June-15-12 1:32:04 PM				(1, 1(1//						ı uş		
Item ID: Revision ID: Item Name:	D206-642-541 Replacement Skidtube			Accept	*N90	0040	100*	Setup	Start Stop	*NS	11*	
Start Date: Required Date: Reference:	15/06/2012 Start (Qty: 1.00 Qty: 1.00	*1* *1*		Cust Iten Custome				Stop	*NS	:ク*	
Approvals:	Process Plan: QC:	Secretary English	Date:	Tooling: SPC (Y/N):		Date:			Start Stop	*NF	11 ⁴	
Sequence ID/ Work Center II	Operati D Descrip			Set Up/ Run Hours	Tool ID	Tool #	Plan Acc Code Qty	cept Reje y Qty			nsp. Stamp	
110 Skidtubes	Skidtubes	Memo		0.00								
Skidtubes		****VERIFY AN 1- Bend FWD en D3274, cut fwd e 2- remove fwd in 3- weld fwd cap a AR Aluminum 4- grind fwd cap 5- Cut AFT end c 6-Drill Aft cap p 7-Cleco DT8025 Drill 3/16" pilot f	and of tube using bend prend of tube with saw table dexing ridge as per dwg as per dwg D3274 and on Rod Batch: weld on top surface on of tube at 170.9" as per dilot hole using DT8025 in position and install proles as per Dwg D3274	g D3274. Prepare for we DSI004 1/20/64 ly dwg D3274 and deburr of	o 10 as per dwg	BE12-07		12-7		2

Item Name: Replacement Skidtube

NCR: 12-1698.		WORK ORDER NON-CONFORMANCE (NCR)												
DATE	STEP	Description of N

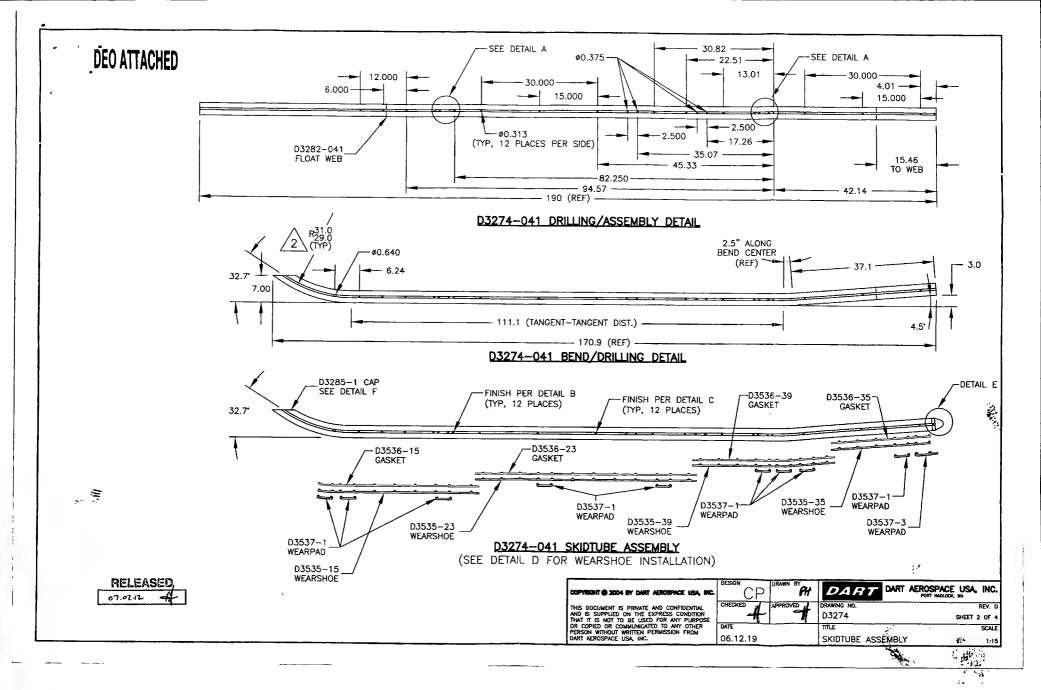
I need to see you as soon as you read this message I have found the counter bore depth on QTYX9 D206 skids are too deep. I am measuring 0.820"-0.830" and it should be at 0.75+/-0.030". I have 6 in progress and 3 already painted and assembled. What happened was that I had inspected some 206 skids and found that the counter bore was correct but I didn't know that they had changed the counter bore part way through the day and was not set up correctly so I had assumed that they were still the same depth and when I measured the first one today like I do always the depth was not correct at all.

I need to know if this will be acceptable or that we need to rework all the skids.

The affected tubes are several float (-541) and regular tubes (-351). The float holes aren't counterbored and are unaffected. As the crossbolt spacers are not loaded except in bearing by the bushings, the additional length of the counterbore would have no effect on the strength of the crossbolt spacer from regular loading conditions. There would be a small reduction in buckling strength from sideways crushing loads, which doesn't represent a critical loading condition per the FAR requirements.

I will accept these tubes based on that rational. This email is an FYI in case you have an objection.

DRAWING NO.	TITLE		REV. D	PART AEROSPACE	USA INCIDEO NO		SHEET NO.	SCALE
D3274	SKIDTUBE AS	SSEMBLY		ENGINEERING O			SHEET 1 OF 1	NTS
DRAWN		CHECKED	B	MFG. APPR.	APPROVED	- 1 . d/	DE APPR.	1410
DATE 0	0.06.17	DATE 09.06	23	DATE 09/06/23	DATE	09/06/23	DATE 09.06.23

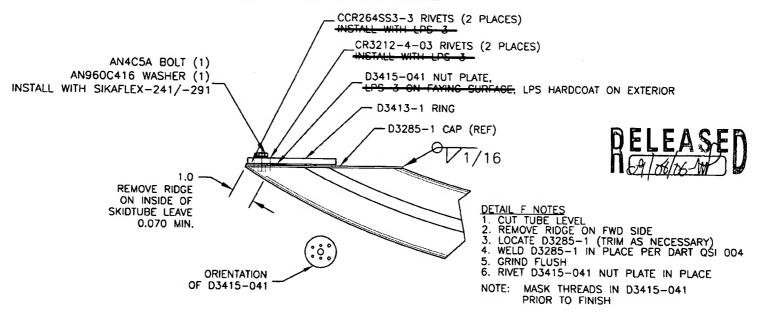
LPS-3 IS NO LONGER USED DURING ASSEMBLY OF SKIDTUBE.

AMEND NOTE 8: "SPRAY INSIDE OF TUBE WITH A COAT OF LPS LABORATORIES 'LPS 3' AFTER FINISH AND INSTALLATION OF INSERTS:

COAT ALL EXPOSED FASTENERS WITH LPS LABORATORIES 'LPS PROCYON' AFTER FINAL ASSEMBLY, CLEAN EXCESS OFF POWDER COATING WITH MEK DEGREASER."

AMEND DETAIL F AS SHOWN:
